# Naval Research Laboratory

NRL/MR/7441--94-7516

## Digital Mapping, Charting, and Geodesy Analysis Program Technical Review of Vector Smart Map Prototypes 1 and 2

January 19, 1995

Figure 18.  $V_{Map}$  and ITD disagreement on placement and number of fords

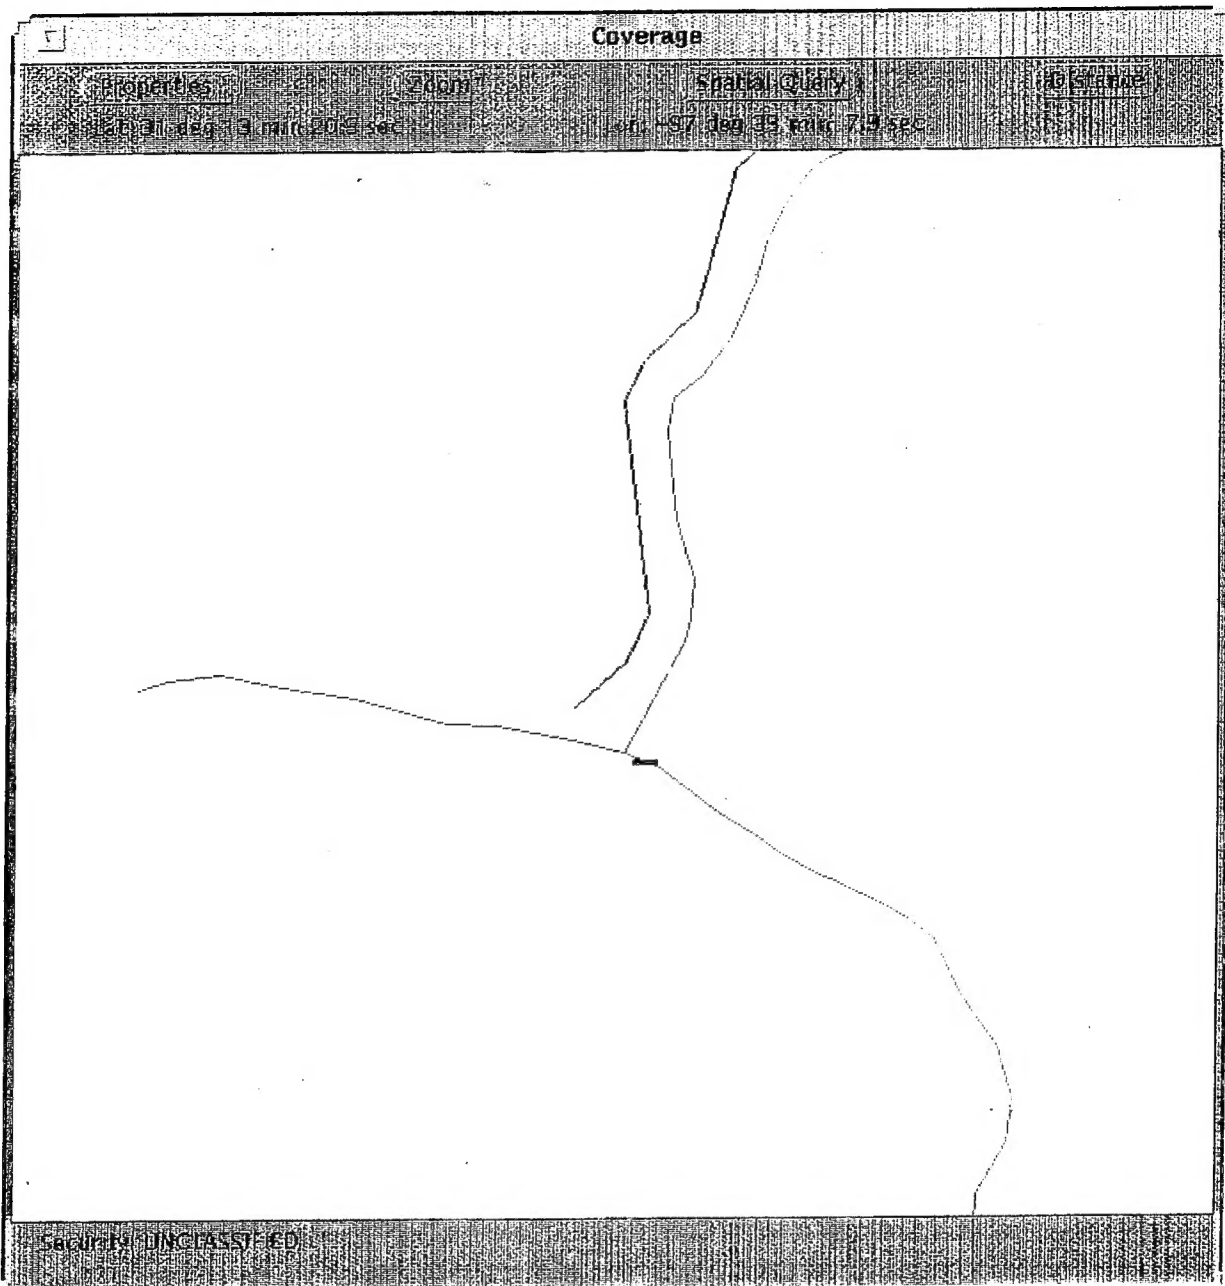
Figure 18 further shows the disagreement between the placement and number of fords.
